VAUGHAN Staff Report Summary

File:	A163/20
-------	---------

21 Twilight Terrace, Woodbridge Address:

Minor Variance Application

PROPOSED PLANS & FOOT PRINT ADDRESS:

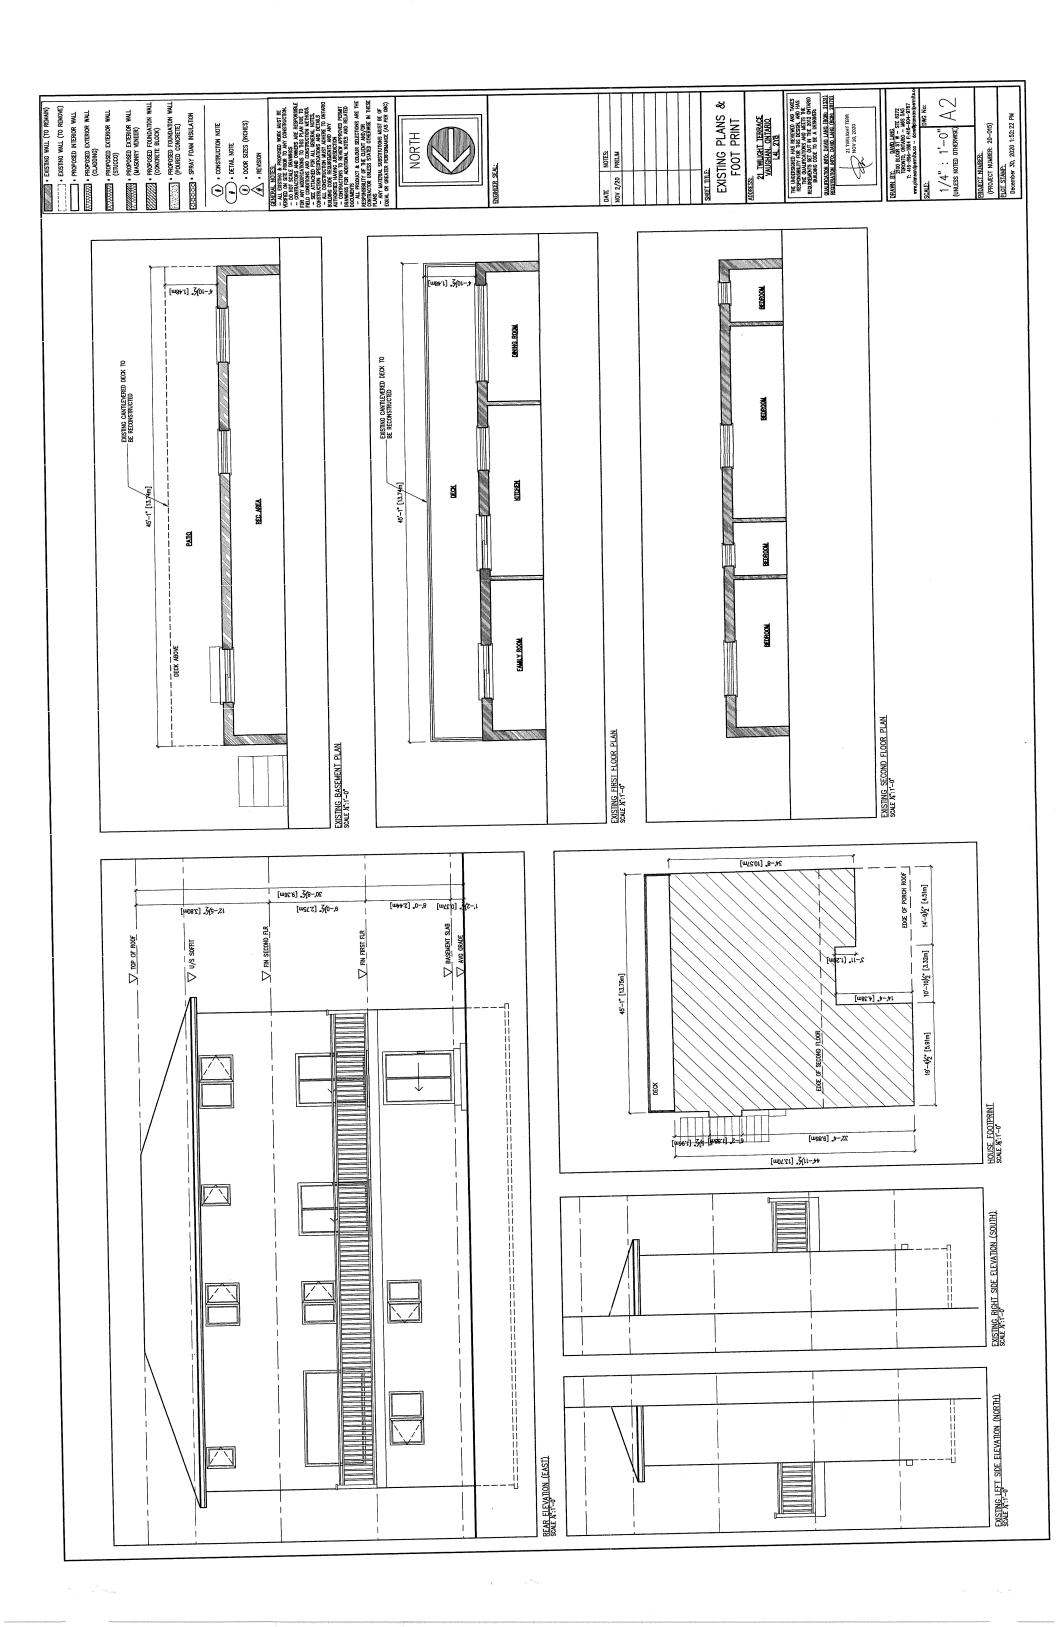
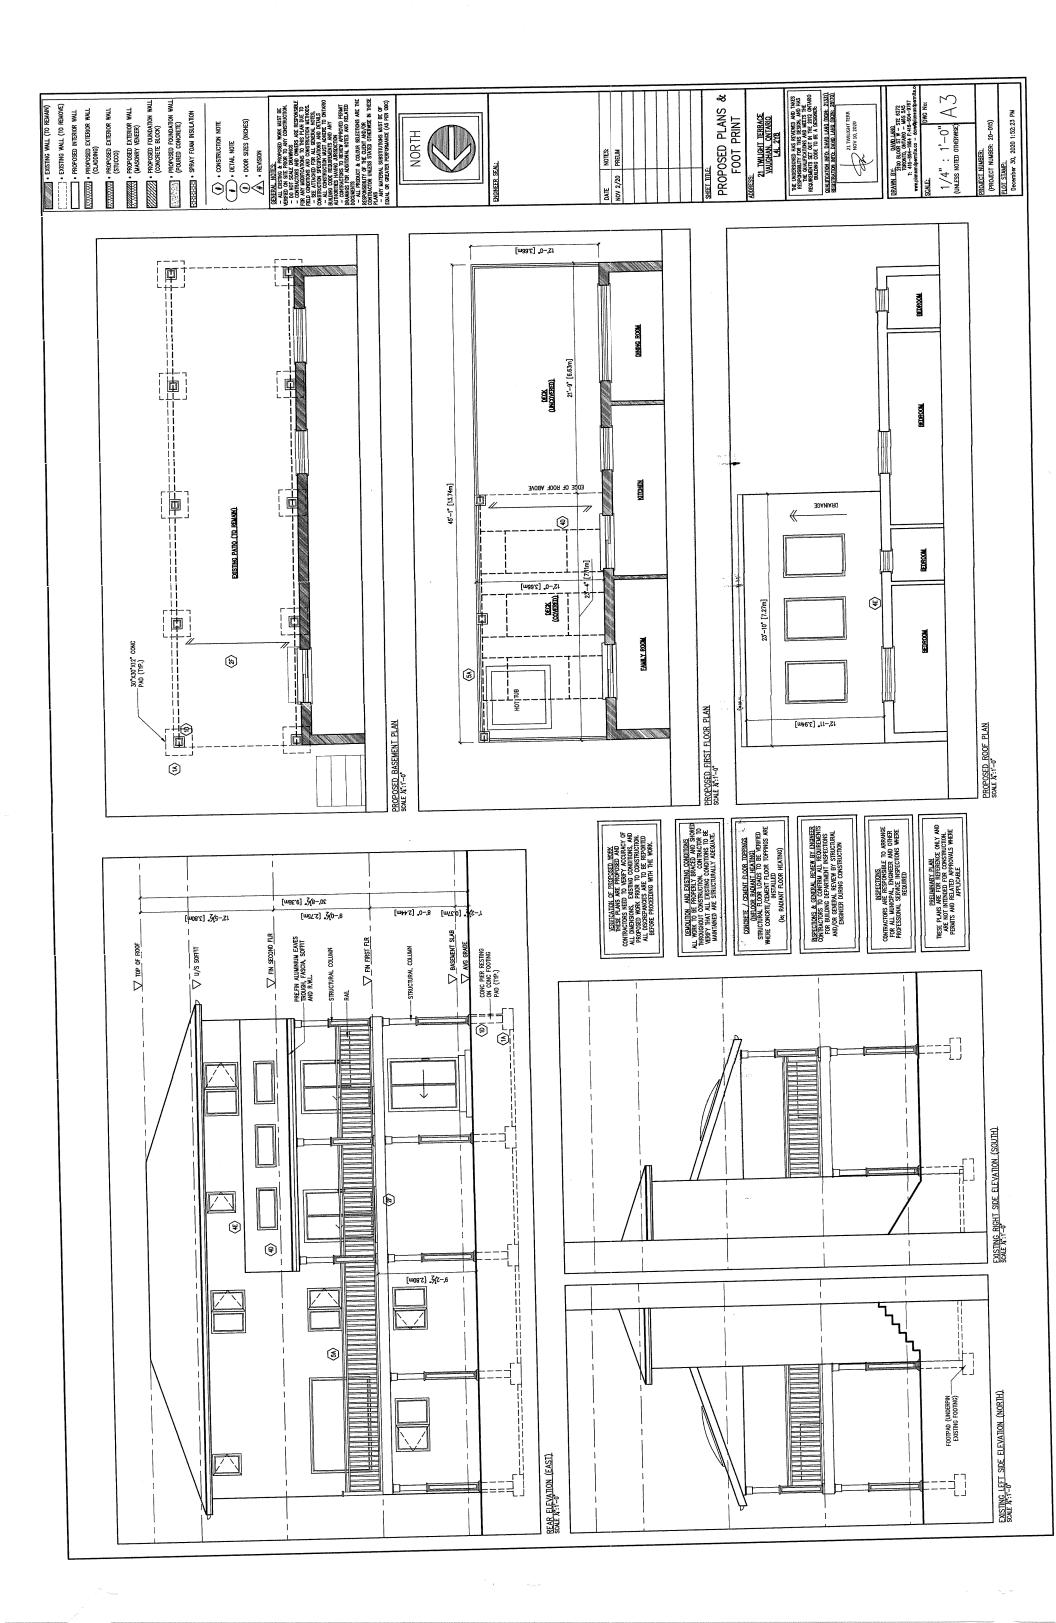
The architectural drawings regarding the permit, depict a Retain Wall establishing the pool deck. It appears that at the North corner of the Retaining Wall is closer to the interior side lot line than the total height of the retaining wall to the pool deck. That is where a retaining wall exceeds 1.0 metres in height, the retaining wall shall be setback a minimum distance from any property line a distance equal to it's height.

Forestry would have concerns regarding future pool installation in rear yard, as indicated in sketch. A tree removal/protection permit would be required if applicant is planning on installing a pool in rear yard.
